PLANNING COMMISSION MEETING STAFF REPORT

NAME OF PROJECT: Reese Burgi Lane Subdivision

AGENDA ITEM: Preliminary & Final Approval

Subject: Reese Burgi Lane Subdivision – Preliminary/Final Review

REESE BURGI LANE SUBDIVISION

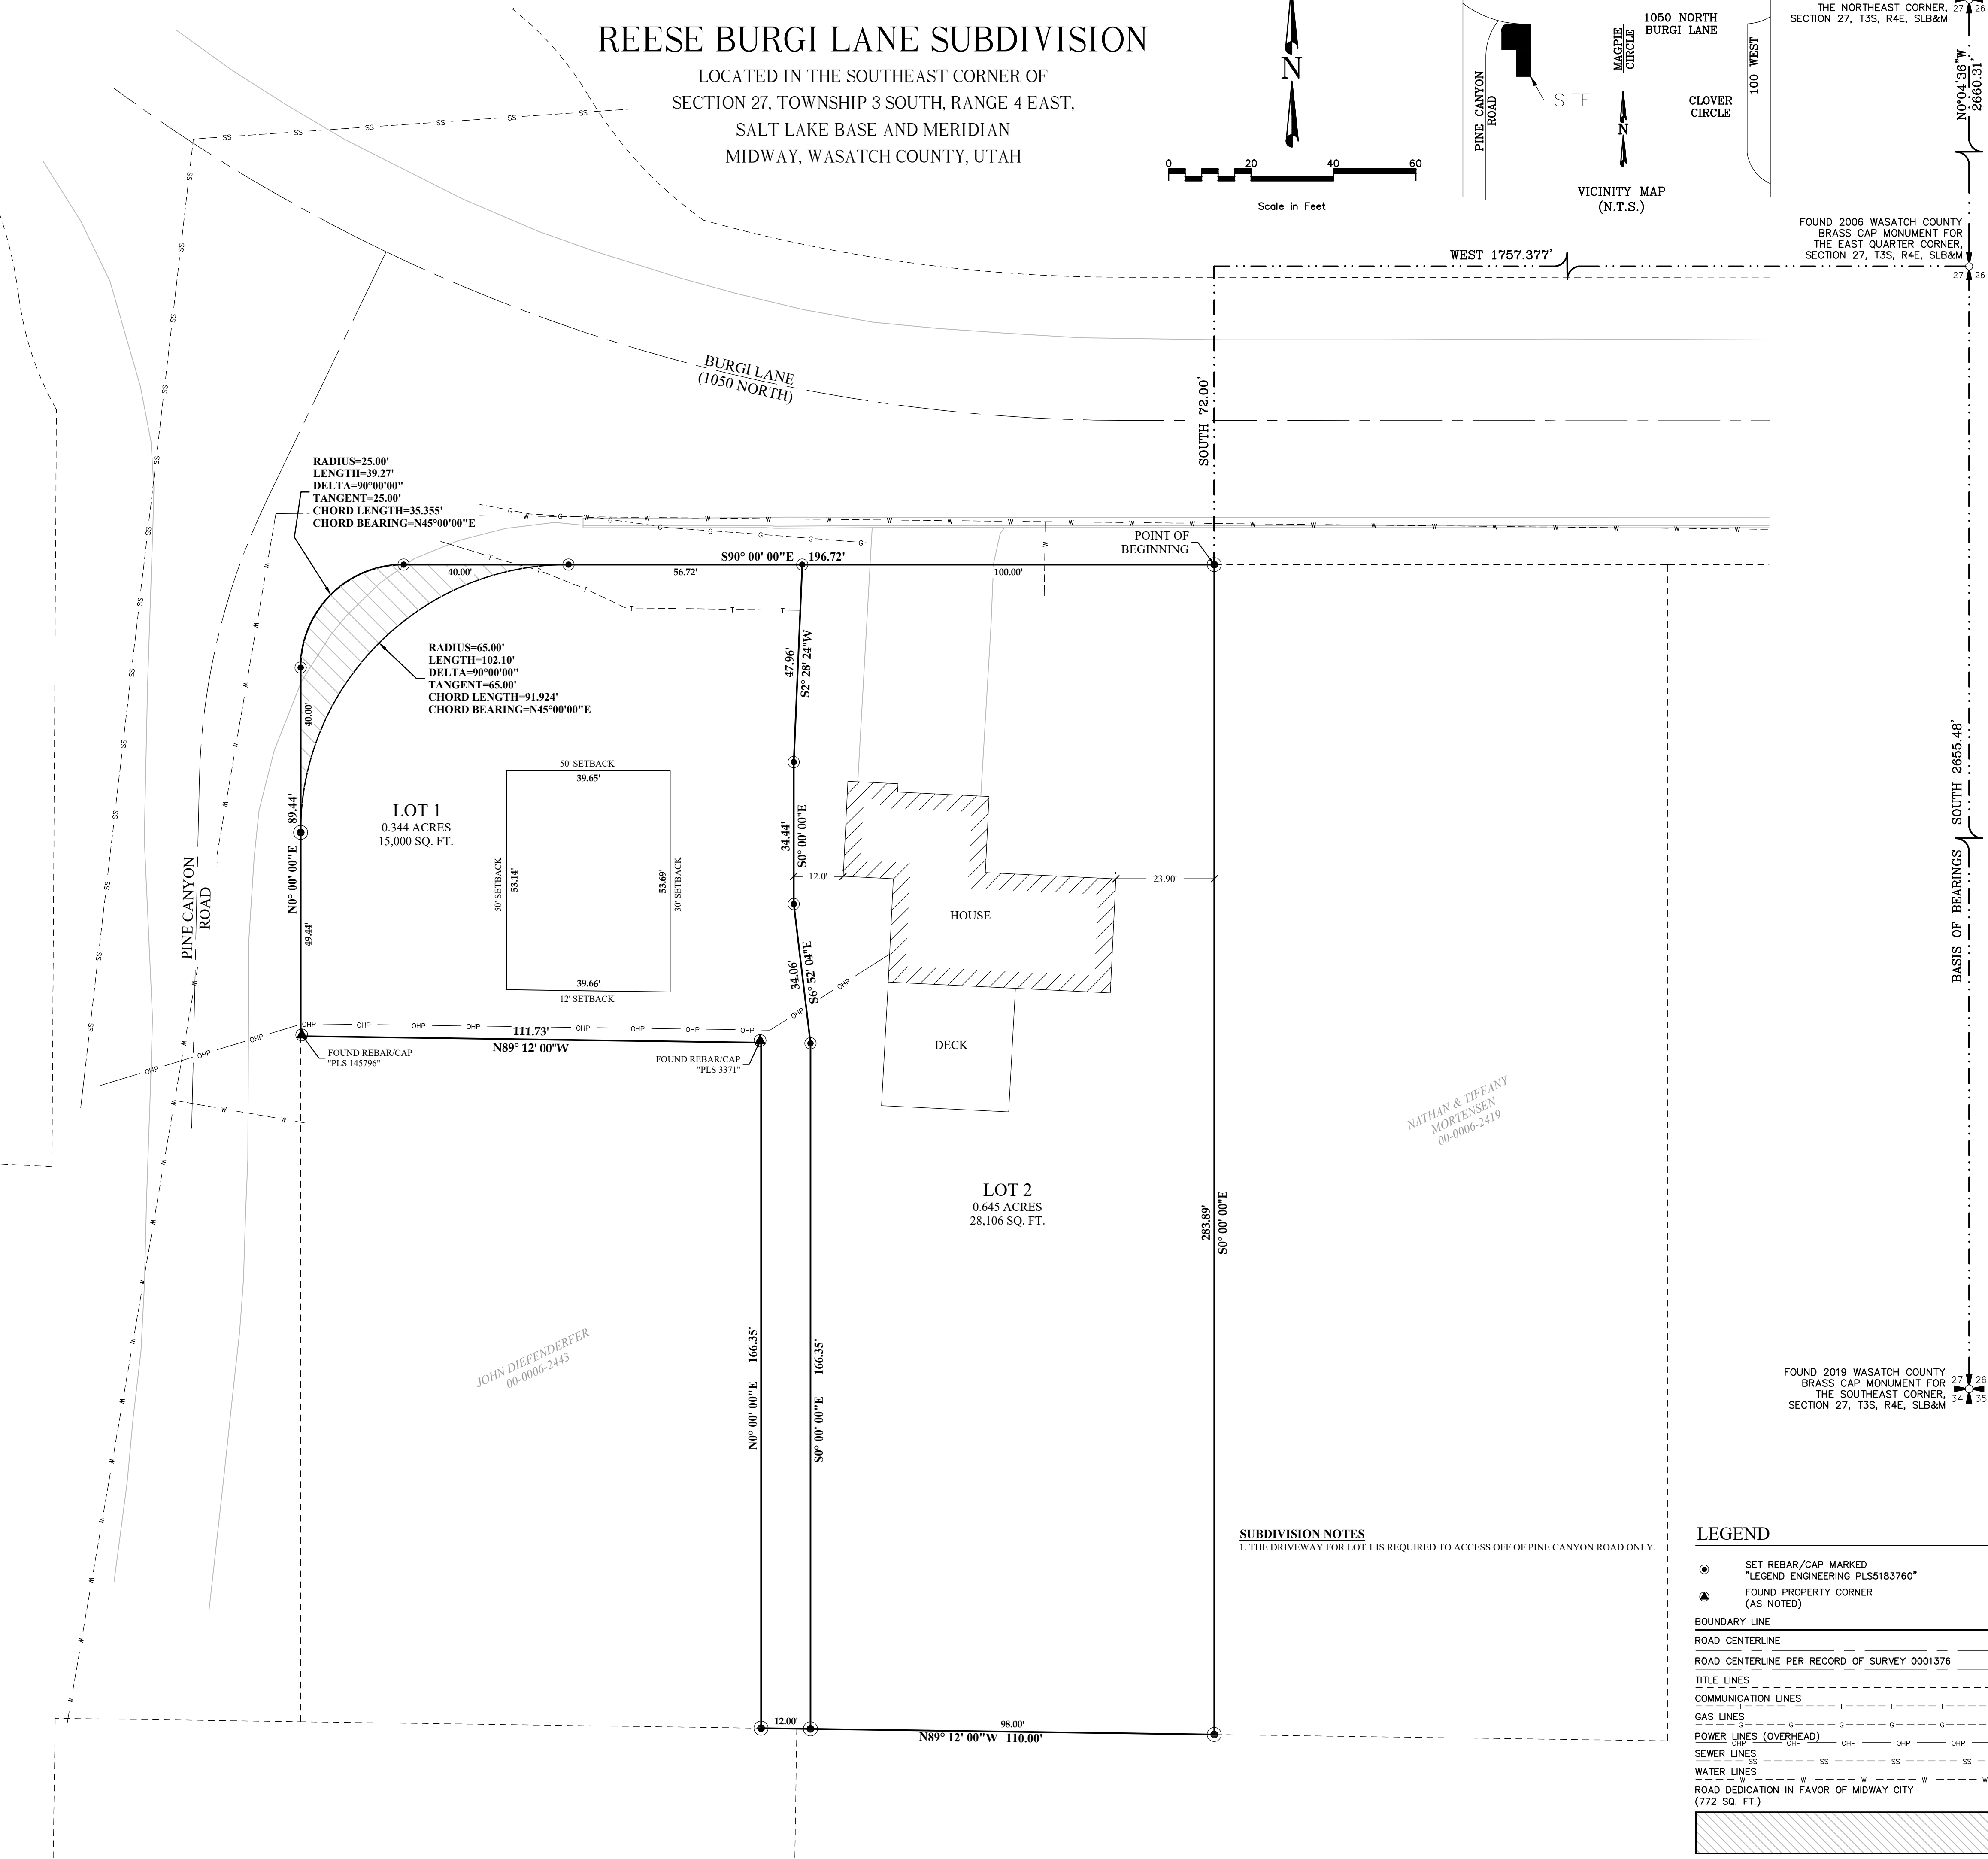
Setbacks –The setbacks from Burgi Lane and Pine Canyon Road per Code is 50 feet. The existing structure on proposed Lot 2 meets this setback from Burgi Lane. For Lot 1, the plat should be required to show a building pad for the dwelling showing compliance with the 50’ setbacks from both Burgi Land and Pine Canyon Road.

Building Pads – Normally building pads are not shown on Midway subdivision plats, but staff finds they could be helpful for proposed Lot 1 given the 50’ required setbacks from Burgi Lane and Pine Canyon Road. It would be easier for future owners to see and understand the setbacks on the plat. If a building pad is shown on the plat, it would be specifically for dwellings and not for accessory structures since setbacks for accessory structures are different than for dwellings.

Intersection and Driveway Location – Lot 2 currently has driveway access from Burgi Lane which shall continue as is. Proposed Lot 1 fronts both Burgi Lane and Pine Canyon Road. Because of the proximity of the intersection of Pine Canyon Road and Burgi Lane, and the projected roundabout at this location, access for Proposed Lot 1 of the development should be limited to Pine Canyon Road and the entire width of the driveway at its intersection with Pine Canyon Road should be required to fall within a distance of 30 feet from the southern property line of proposed Lot 1.

- To avoid the Burgi Lane Pine Canyon intersection the proposed driveway should connect to Pine Canyon road. The driveway should be on the South side of the proposed lot and contained within 30'.

2. Driveway access to Proposed Lot 1 shall be restricted to Pine Canyon Road and the entire width of the entrance to the driveway from Pine Canyon Road shall be located within 30 feet from the southern property line of proposed Lot 1.

3. The plat shall show a building pad for the dwelling on Lot 1.
